April 16, 2020

## EX PARTE VIA ELECTRONIC FILING

Re: Unlicensed Use of the 6 GHz Band, ET Docket No. 18-295; Expanding Flexible Use in Mid-Band Spectrum Between 3.7 and 24 GHz, GN Docket No. 17-183

Figure 2: Terrain Considerations for Example 2

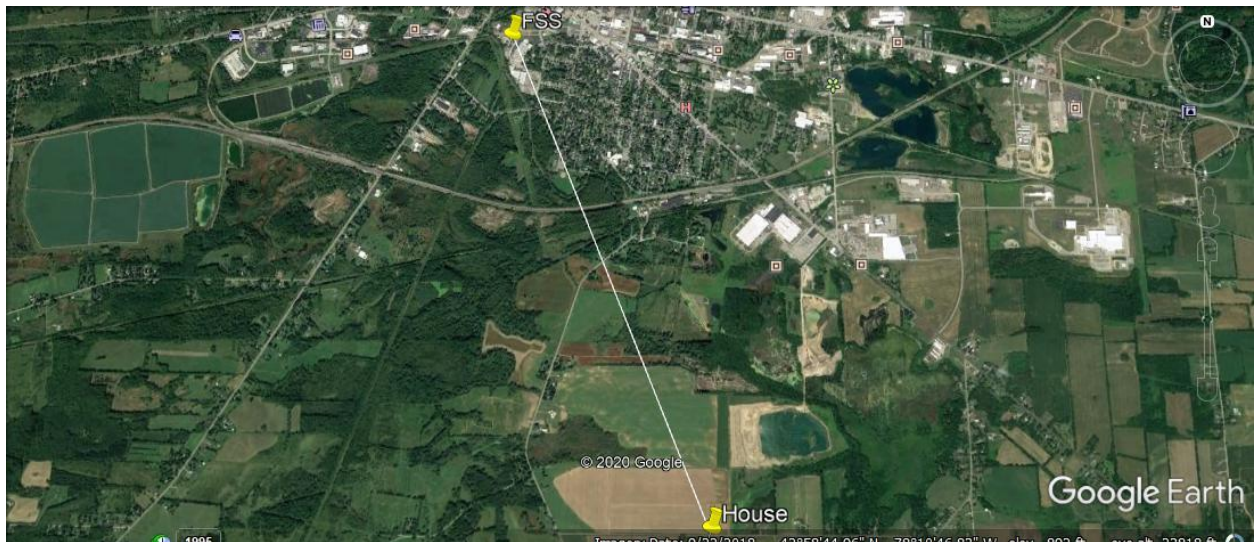
However, the table in the *Draft Order* contains other serious errors as well. In both Example 2 and Example 3, the *Draft Order* applies a -18.4 dB clutter loss factor. Looking at the terrain profiles and land area for both examples, however, shows that in both cases the value applied is radically overstated. In Example 2, a Google Earth terrain profile shows no terrain obstructions—remembering that the microwave receiver is located 27.4 m above ground level and, that while the terrain profile exaggerates height differences, the total height variation in the profile is only 24 feet:

With elementary geometry, even if a tree was located at the worst point in the terrain profile, it would have to be in excess of 12 m tall to affect the microwave signal. And even if a few trees did reach that height, 18.4 dB of attenuation is vastly overstated. At most, even in the worst case, 10 dB of attenuation would be conservative.

Figure 1: Possible lab set-up to determine the impact of RLAN interference to fixed service radios at 6 GHz

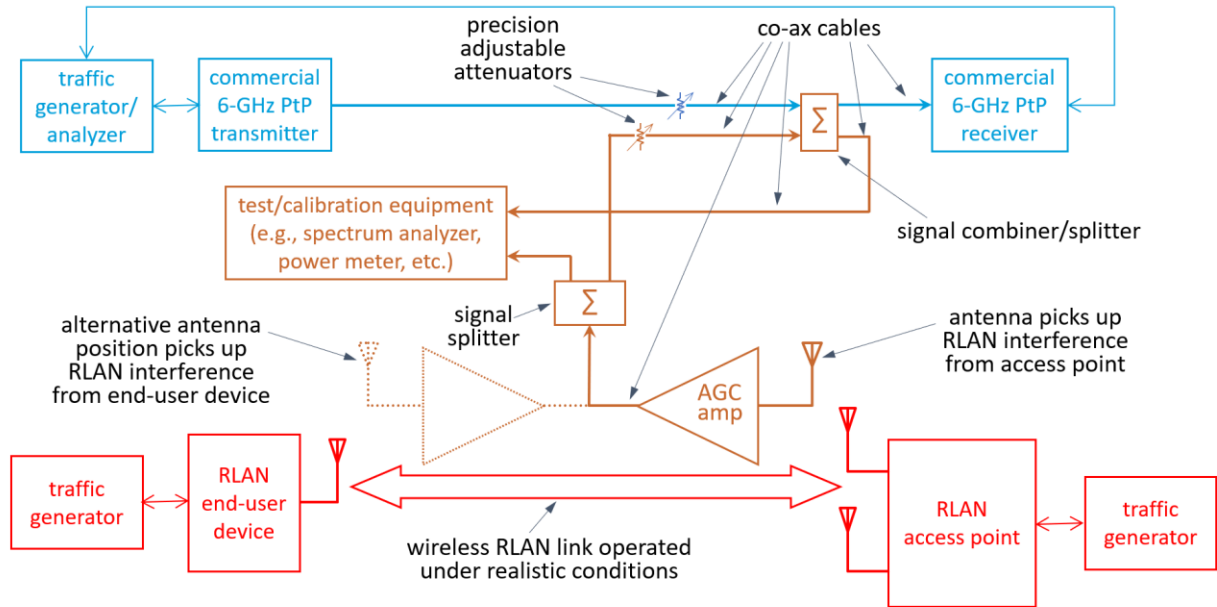
Tests should be performed on various 6 GHz point-to-point systems, transporting TDM and various frame size Ethernet payloads, operating at different channel bandwidths, with various static and adaptive modulation levels. The impact on these systems from RLAN devices, operating at different channel bandwidths and different throughputs (and presumably different activity factors) for different C/I levels should be investigated.

These tests can be performed in a properly equipped lab with representative 6 GHz point-to-point systems and RLAN devices. See the cabling diagram below regarding how equipment under test could be configured.
